**ANGEL PLACE
LEVEL 8, 123 PITT STREET
SYDNEY NSW 2000**

RE: SSD-9726 – ROYAL HALL OF INDUSTRIES - RESPONSE TO REQUEST FOR FURTHER INFORMATION

Table 1 Response to RFI

Figure 1 Encroachment of Trees 8 and 9 with the heritage wall of the site.

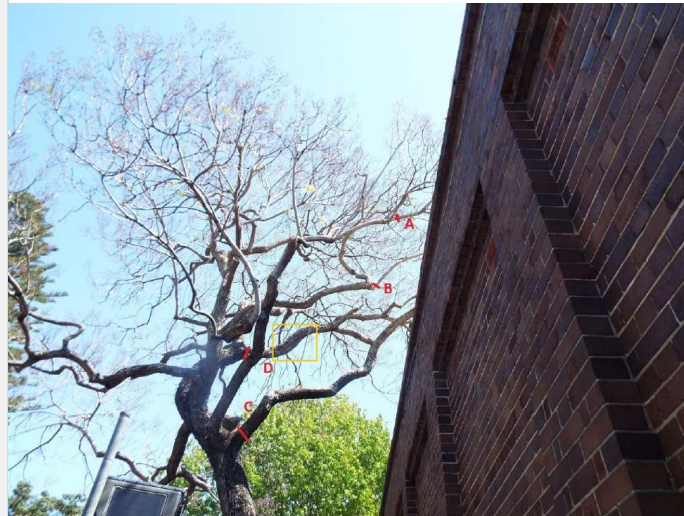
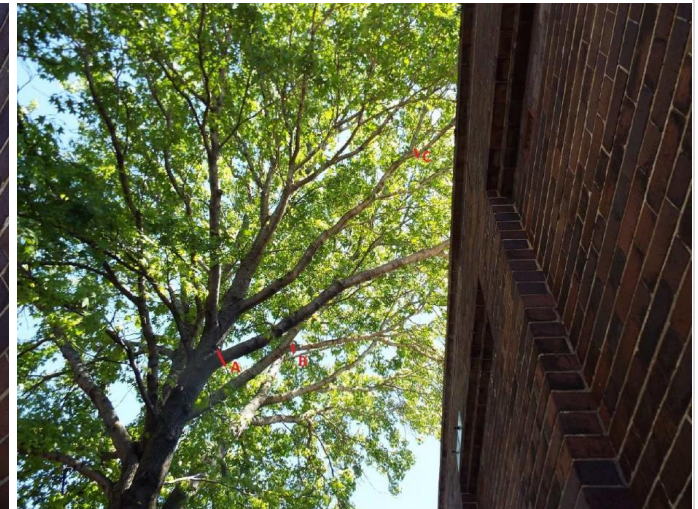
City of Sydney Comments	Proponent Response
	Swept Paths – Updated Swept Paths have been prepared by GTA and are provided at Attachment A .
<i>Public Domain</i>	N/A
<i>Landscape and Tree Management</i>	<p>The CoS submission states that the required information for trees 22, 36, 56 and 61 were omitted from the documentation. Analysis of these trees was undertaken in the initial Arboricultural Report (Reference D3355) submitted in the SSDA package in June 2019, and the Arborist Addendum prepared by Allied Tree Consulting (Reference 3355A) submitted in the Response to Submissions package in November 2019. For consistency, the table at Attachment B outlines the referenced trees, the project impact and the required tree protection measure.</p> <p>Further, it is suggested that the proposed pruning to trees 8 & 9 are conditioned to be dealt with separately through the ‘Limit on Consent’ condition.</p> <p>Discussion of the impact of the project on Trees 8 and 9 is discussed in the Arboricultural Report (Reference D3355) submitted in the SSDA package in June 2019, and the Arborist Addendum prepared by Allied Tree Consulting (Reference 3355A) submitted in the Response to Submissions package in November 2019.</p> <p>The ground floor of the proposed NSB will conflict with the low-hanging branches of Trees 8 and 9 which extend over the heritage wall and into the site, as illustrated in Figure 1. The height of the NSB ground floor exceeds the height of the tree dripline, and as such pruning will be required to enable the construction of the building and the ongoing health of the trees. Whilst it is acknowledged that Level 1 of the NSB will not conflict with the tree dripline due to the setback, the dripline will encroach into the Ground Level roofline.</p>

As outlined above, the portion of pruning is not excessive and is required to enable the development of the NSB, specifically the Ground Level roofline. It is suggested that the proposed pruning to trees 8 & 9 are conditioned to be dealt with separately through the 'Limit on Consent' condition.
